1990 - 1991 Corvette: Service Bulletin: Intermittent Electrical Conditions - Repair/Diagnosis Procedures

Model and Year: 1990-91 CORVETTE

Source: Chevrolet Service Bulletin

Bulletin Number: 91-337-6D - (05/30/1991)

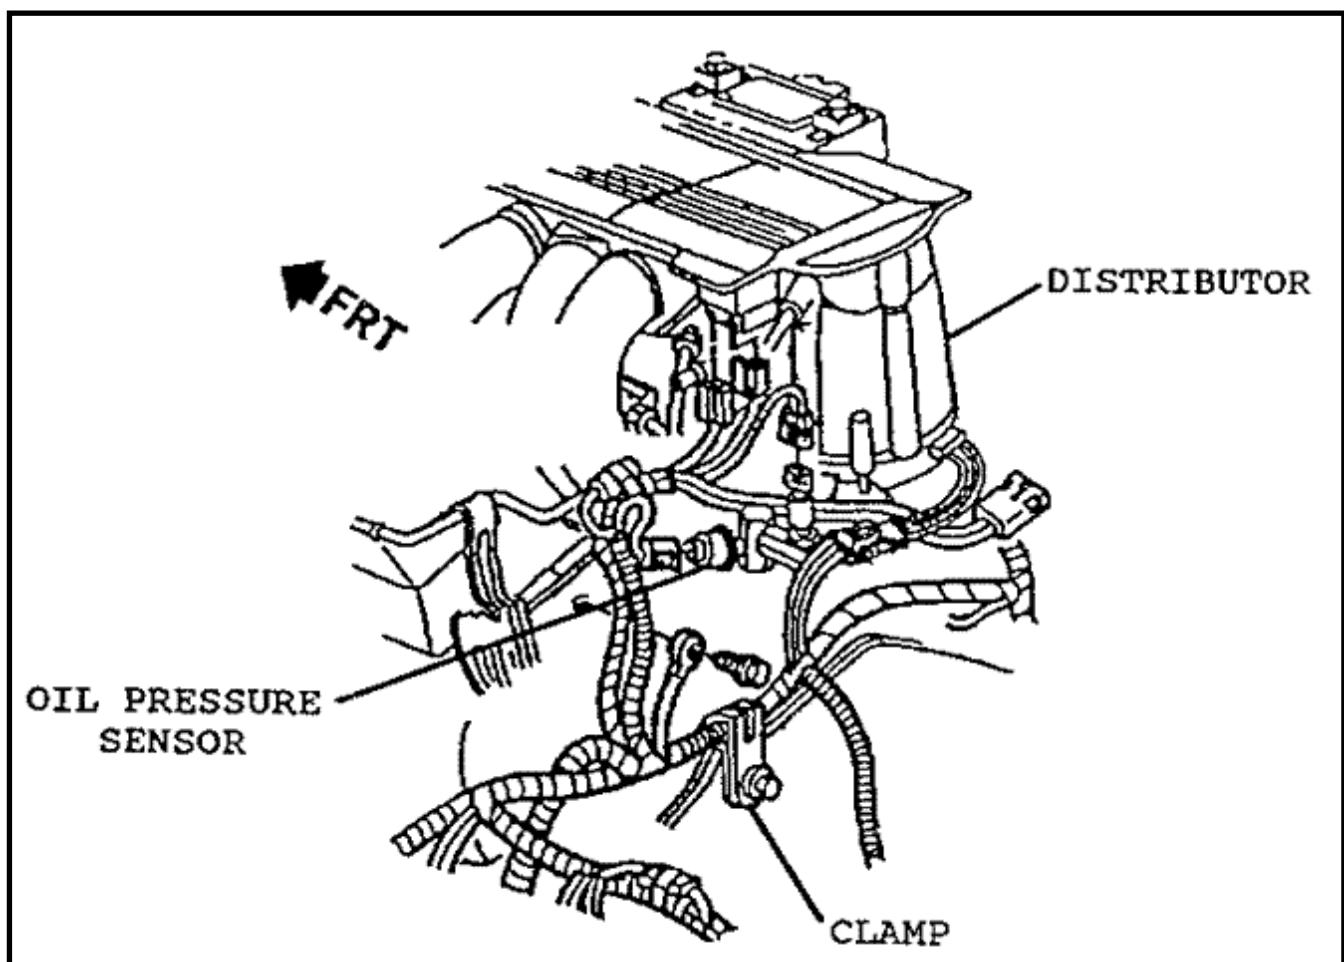
The electrical system on the 1990-91 Y Car may have one or more intermittent electrical conditions that are very difficult to diagnose. These conditions are often related to engine electrical operation, and may or may not set codes.

The engine electrical harness may be rubbed thru by the mounting clamp just below the oil pressure sensor (see illustration). The conduit covering the harness may be positioned so that the tab on the clamp can enter the harness thru the slit, allowing the clamp to contact the wires, which are then rubbed thru with the normal movement of the engine.

1. Disconnect negative battery cable.
2. Remove windshield wiper motor.
3. Remove harness from clamp. Carefully inspect the wires for rub thru spots,

and correct the damage as necessary.

4. Wrap the harness with electrical tape. Replace the conduit, then overwrap the outside of the harness with more electrical tape. Secure the harness to the clamp so that the tab cannot enter the harness.
